STAFF REPORT

TO: City Council
FROM: Emily Becker, Planning Director
AGENDA ITEM: The Legacy at North Star Final Plat and Planned Unit Development Plans and Zoning Map Amendment
REVIEWED BY: Jack Griffin, City Engineer

GWSA Land Development is requesting Final Plat and PUD Plans for 59 single family detached homes located on 23.26 acres. This is the 1st phase of a 266 single family residential development on +/- 98.93 acres. A portion of the development in the southwest corner of the site is within the Shoreland of Sunfish Lake which triggers the need for a Planned Unit Development because the proposed lots do not meet the lot width and impervious requirements for Natural Environment lakes; because the density exceeds the allowable density with the Village Urban Low Density Residential land use category, and because the Applicant is proposing various other deviations from some zoning standards.

Request: Final Plat and Development Stage PUD Plans and Zoning Map Amendment

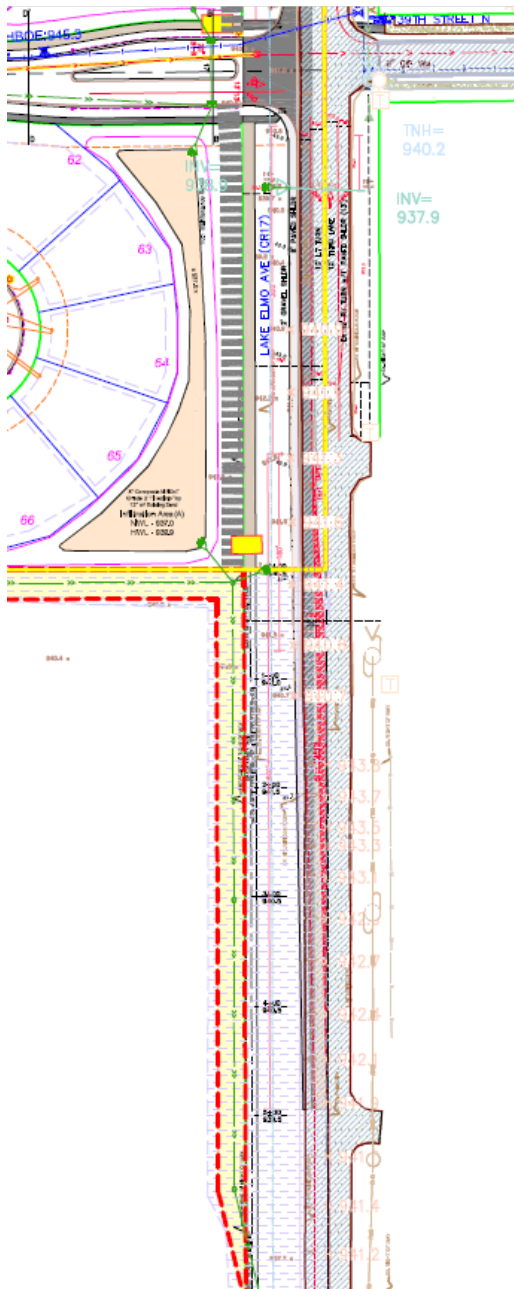
Another condition was that a trail be provided from 39th Street to the southern limits of the plat and that the future County right-of-way area along Lake Elmo Avenue of the parcel to the south

of the plat be graded for a future bituminous trail extension (grade ready trail) along the storm sewer outfall pipe location.

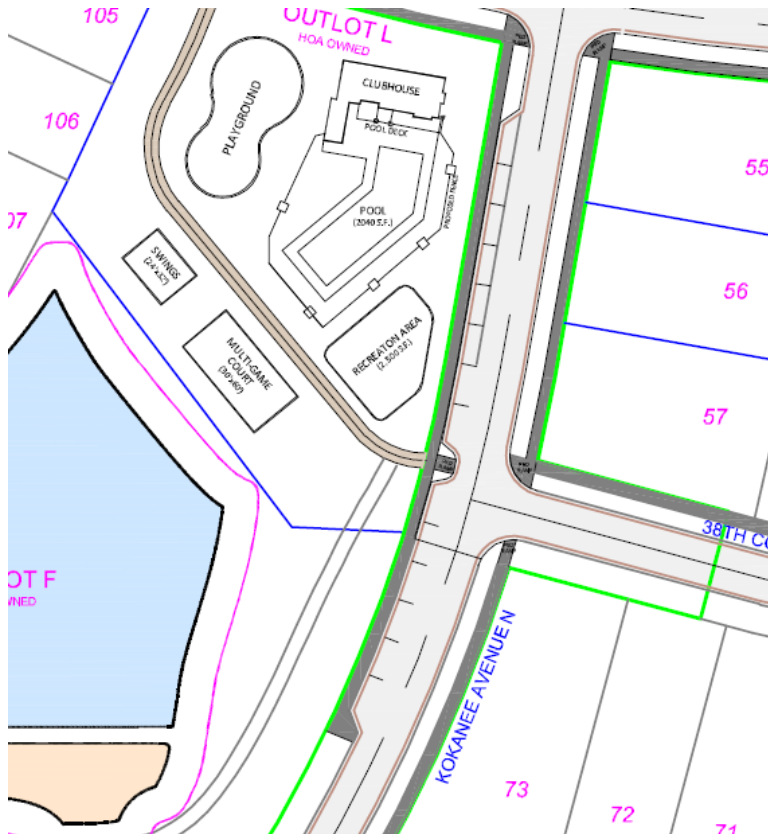
- 13. That wetlands and wetland buffer areas be contained within outlots outside of lot areas and dedicated to the City.*

The preliminary plat shows that with buffer averaging this wetland buffer has been contained within Outlot N of the preliminary plat. This condition is not applicable to the 1st Addition.

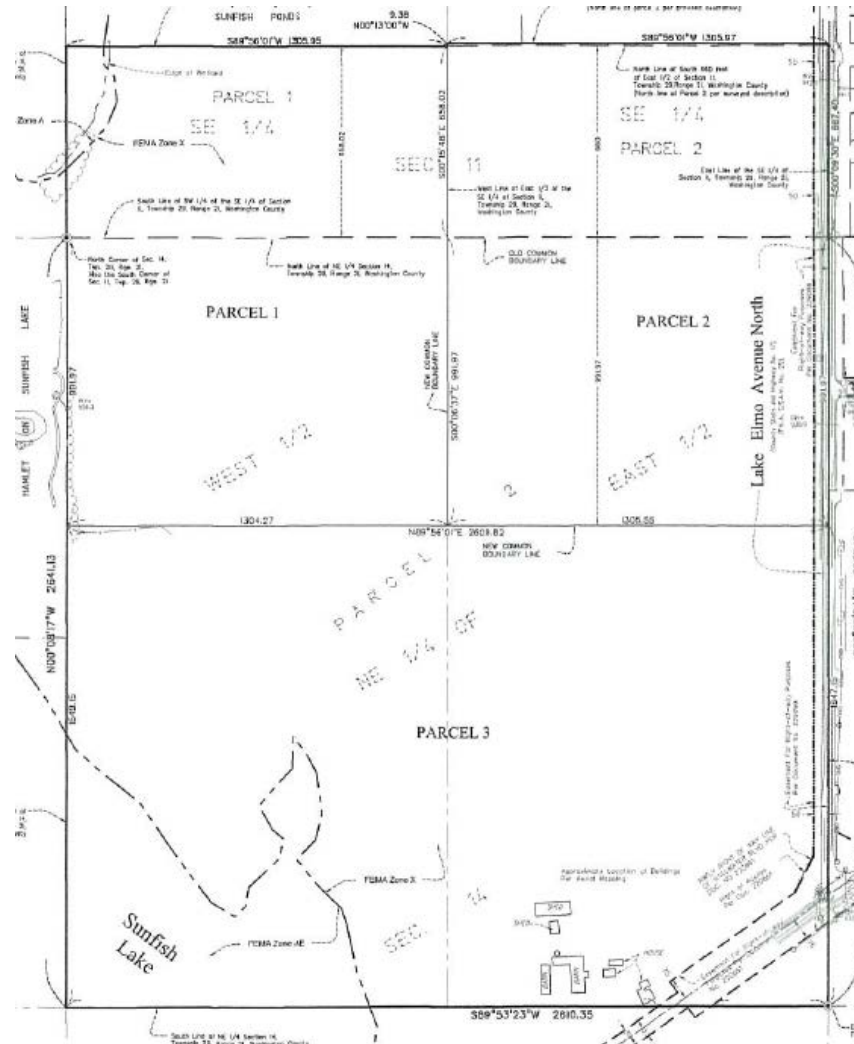
25. *That the Applicant construct a bituminous trail extending south along the County right-of-way from 30th Way to the southerly plat limits (along the east side of Outlot C) and the future County right-of-way area along Lake Elmo Avenue of the parcel to the south of the plat should be graded for a future bituminous trail extension (grade ready trail) along the storm sewer outfall pipe location.*

This has been shown on the construction plans.
